COAL PAP AMENDMENT/REVISION/NOV & EXPLORATION TRACKING FORM  
(Revised: 9/14/87)

Title of Proposal: SKYLINE BREAKOUT - As Built

Company Name: UTAH FUEL CO.

Re: M&RP Permit Amendment, Breakout in South Fork of Eccles  
Creek, Mine #1

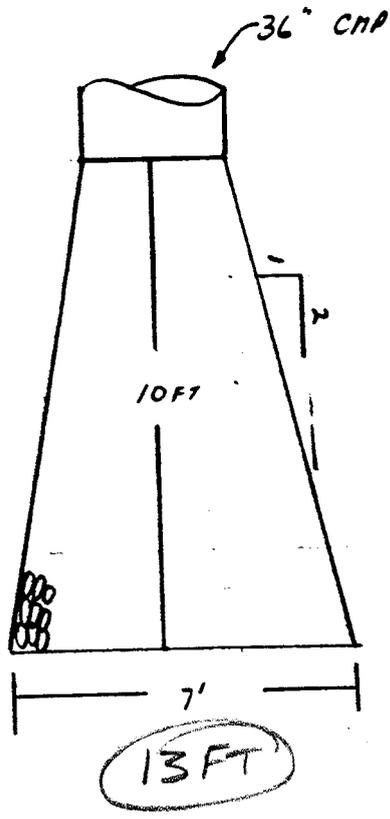
MAX ROCK SIZE  $1.5 \times D_{50}$

$D_{50} \approx .33 \text{ FT} \quad 0.4 \text{ FT}$

$Q = 39.1 \text{ CFS} \quad D = 3 \text{ FT} \quad d_{50} = .33 \text{ FT} \quad LA = 10 \text{ FT}$   
 $31.5 \text{ CFS} \quad 2.9 \text{ FT} \quad 10 \text{ FT}$

$W_A = D + LA = 3 + 10 = 13 \text{ FT} \quad d_{max} = 1.5 \times d_{50} = 1.5 \times .33 = .5 \text{ FT}$   
 $0.6 \text{ FT}$

APPLICANT STATES ON PG. 16 DESIGN FOR  
 $TW < 0.5D$ .

STREAM RECLAMATION

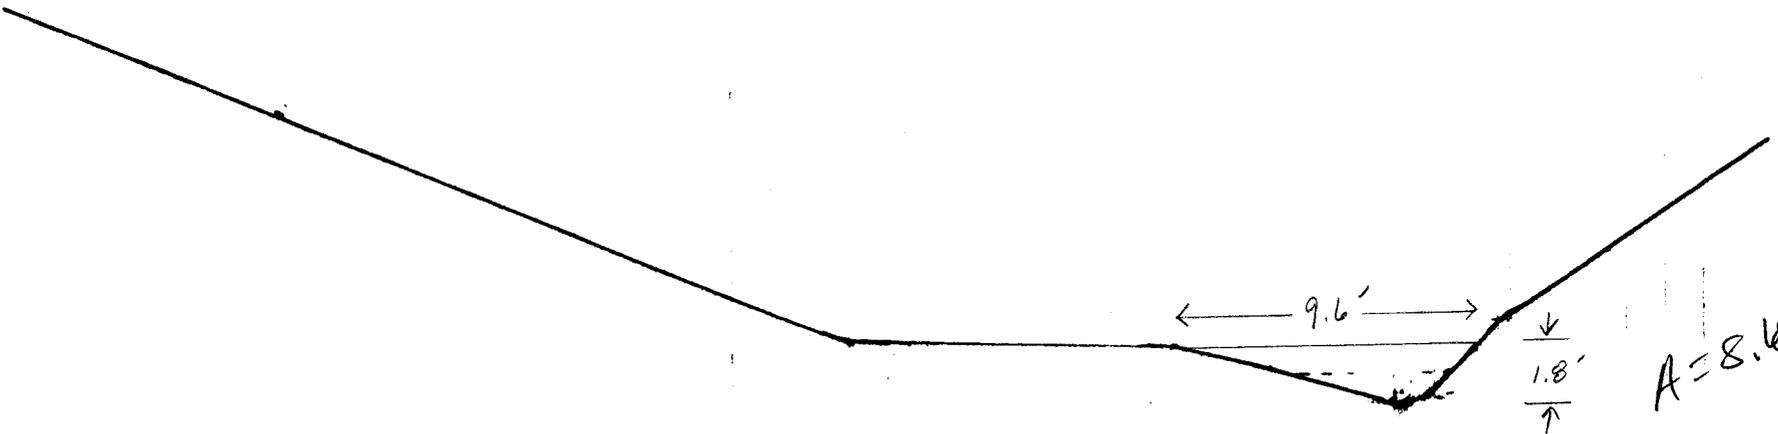
The plan requires construction of a new road section across the upper drainage. The plan presents adequate calculations for culvert sizing in this section but contains no designs for inlet protection or outlet structures. The application must include plans for inlet protection and designs for an adequate energy dissipator for the South Fork culvert outlet.

- OK 1. Plans to bed the culvert in washed gravel in order to minimize contributions of sediment to the stream during installation and removal.
2. A detailed reclamation plan for the channel crossing. This information should include a survey of the existing stream channel, plans to meet the requirements of UMC 817.44 subsections (b) and (d), plans demonstrating the restored channel will have a capacity at least equal to the upstream and downstream sections (i.e., channel cross-sections), plans to restore the channel with a channel slope approximating the pre-disturbance condition. The calculations presented in the submittal utilize the incorrect formula for the hydraulic radius. It appears the formula was used for a triangular channel to approximate the channel. The formula used was:

Details of the reclamation plan must be submitted including a survey of the existing stream channel demonstrating that the restored channel will have a capacity at least equal to the upstream and downstream sections (i.e., channel cross-sections) and plans to meet the requirements of 817.44 (d). *The submitted channel cross-section does not adequately demonstrate the existing channel*
